Radial International Ltd. (Unit-2) (Extension)

Zirani Bazar, Kashimpur, Gazipur
(23.998095, 90.255065)
12 November 2025

1. Executive Summary

Observation 03: Lack of floor load management (Saara Complex Building)

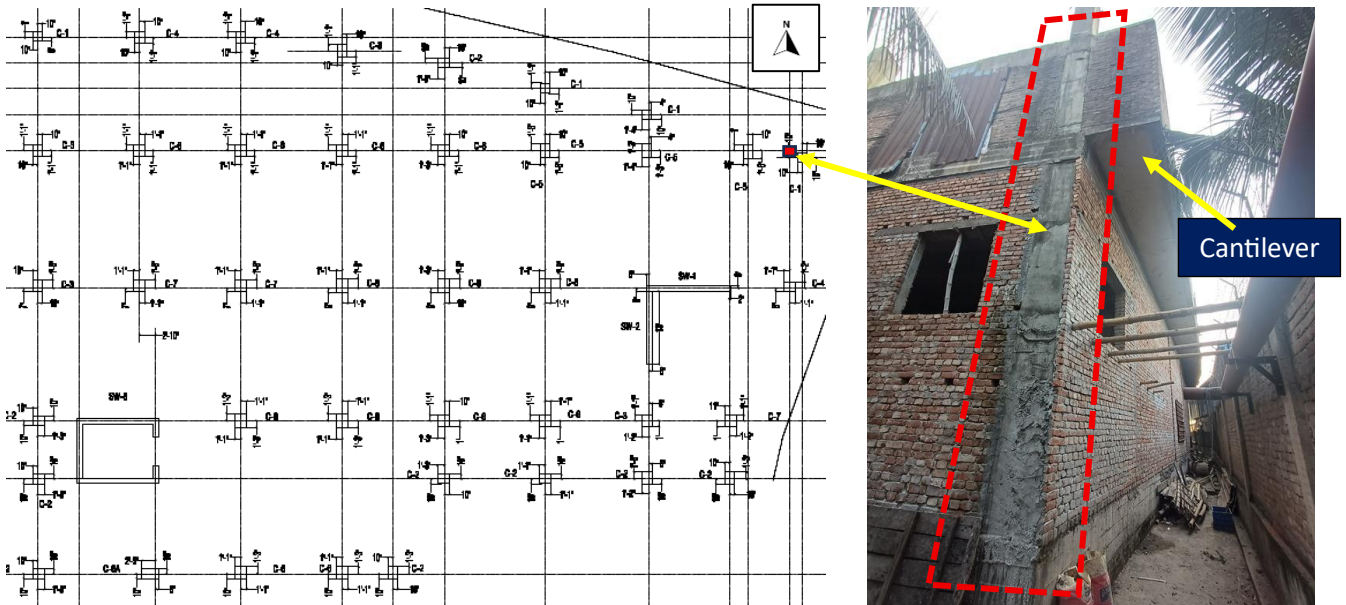
Description: During the inspection, the building was found to be used for storage; however, no load plan or storage area and height markings were provided. The building engineer is required to produce load plan as per BNBC, post the load plan at each floor, provide a storage area & height marking and maintain floor loading accordingly.

6.	Lack of floor load management (Saara Complex Building)	Provide storage area & height marking and maintain floor loading accordingly.	within 6 weeks
7.	Discrepancies in the as-built drawing (Saara Complex Building)	The building Engineer is required to survey the entire structure and update the drawings to reflect the on-site conditions.	within 6 weeks

Observation-4: Discrepancies in the as-built drawing (Saara Complex Building)

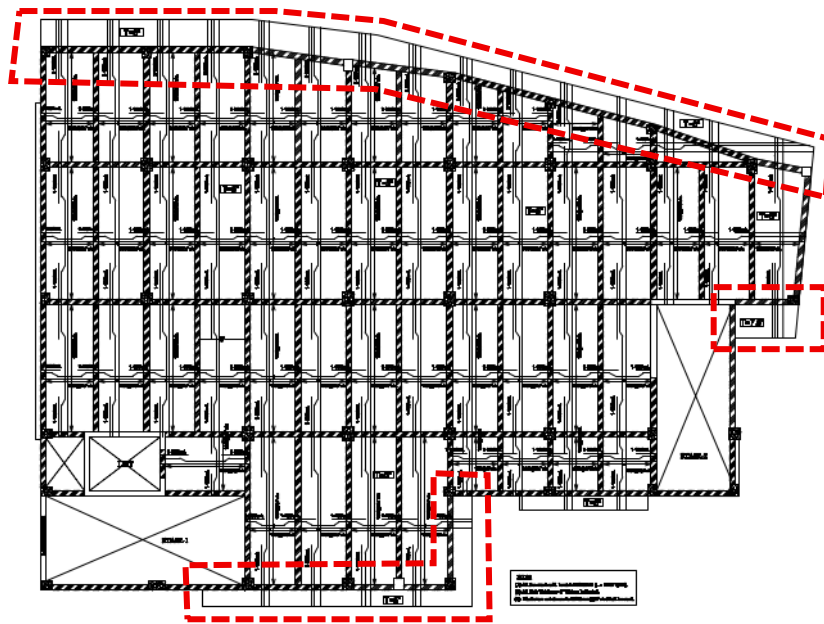
marked column was shifted west

Description: Several discrepancies were identified, such as relocation of the marked column and the cantilever dimension being missing in the drawing. The building Engineer is required to survey the entire structure and update the drawings to reflect the on-site conditions.

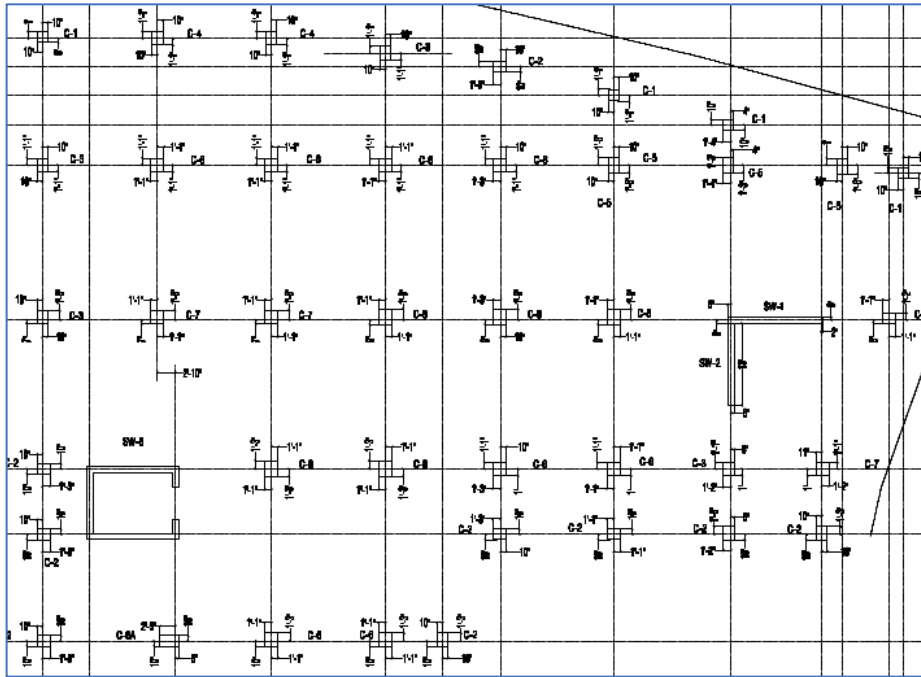
Dimension of cantilever portion – not mentioned
